# 1984 Corvette: Service Bulletin: Generator Noise (Moan) at Idle with Air Conditioning On

**Model and Year:** 1984 Corvette

**Source:** Chevrolet Dealer Service Bulletin

**Bulletin Number:** 84-151, Section 6D (VIy)

FIGURE 1

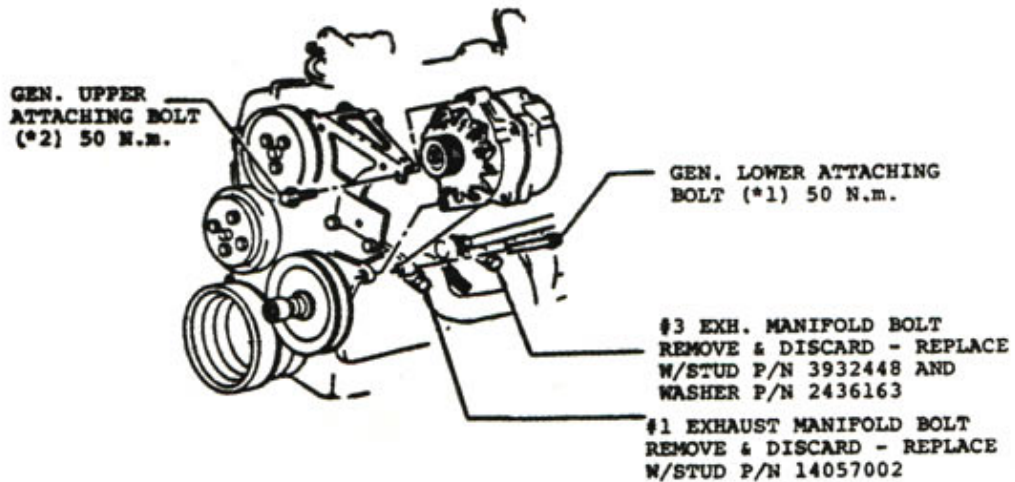
Some 1984 Corvettes may exhibit the subject noise, which is commonly defined as a "moan". This noise is induced into the generator by belt excitation when the air conditioning compressor is "on".

The following service procedure has been developed to reduce this noise by using three (3) new tubular braces and fasteners to replace the generator vibration period, which is the primary noise source.

1. Remove the generator rear support brace. Discard the support brace, attaching nut and attaching bolt.
  2. Remove and discard #1 and #3 L.H. exhaust manifold to cylinder head attaching bolts (see Figure 1).

- NOTICE: Washer is to be installed on stud between stud hex and exhaust manifold.
5. Remove the serpentine belt from the generator pulley.
  6. Loosen generator attaching bolts (2). (See Figure 1).

3. Install stud, P/N 14057002, in place of discarded #1 bolt and torque to 35 N.m.
  4. Install stud, P/N 3932448, and washer, P/N 2436163, in place of discarded #3 bolt and torque to 35 N.m.

9. Mandatory torque sequence (Figures 1 and 2):

- Generator lower attaching bolt 50 N.m.
- Generator upper attaching bolt 50 N.m.
- Long tubular support brace to generator, attaching bolt 35 N.m.
- Two (2) short tubular support braces to generator, attaching bolt 50 N.m.
- Three (2) tubular support braces to three (3) exhaust manifold studs, 25 N.m. three (3) attaching nuts.

FIGURE 2

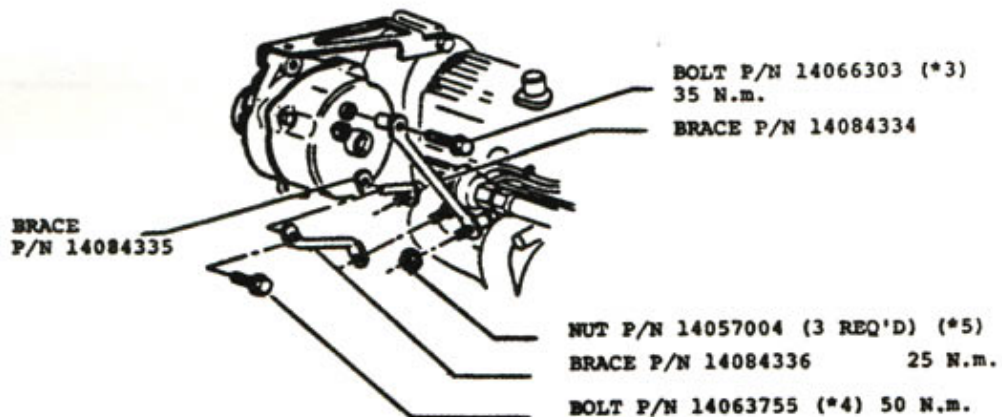
7. Install three (3) tubular braces on the exhaust manifold studs as shown on Figure 2 and loosely retain with attaching nuts in three (3) places.
  8. Install bolt, P/N 14066303, in longer single brace and bolt, P/N 14063755, in two (2) short braces. Loosely install bolts into generator housing (see Figure 2).

The B+ wire on the generator should not contact the support brace(s). If necessary, disconnect the battery and loosen the B+ cable eyelet, on the generator, and rotate the B+ wire to clear the support brace(s). Re-torque the eyelet attaching nut and install the battery cable.
